### XL-R5010BK

#### Supplement

We will issue an supplement version because there was a part where the explanation is insufficient in the service manual (issue No. A0011 CD-ROM No.SML200107) which has already been issued.

#### ■ Service menu (page 1-17)

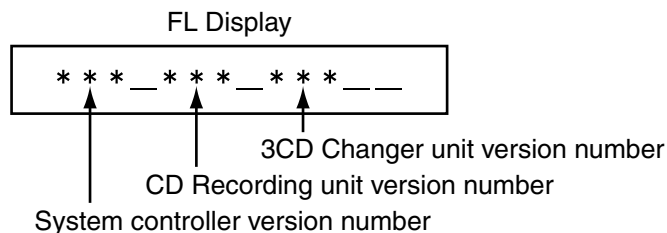
There is an item displayed besides "SYSTEM\_AGING" and "READ\_VERSION" in the service menu. However, because the effective item is only "SYSTEM\_AGING" and "READ\_VERSION", the function does not actually use other items.
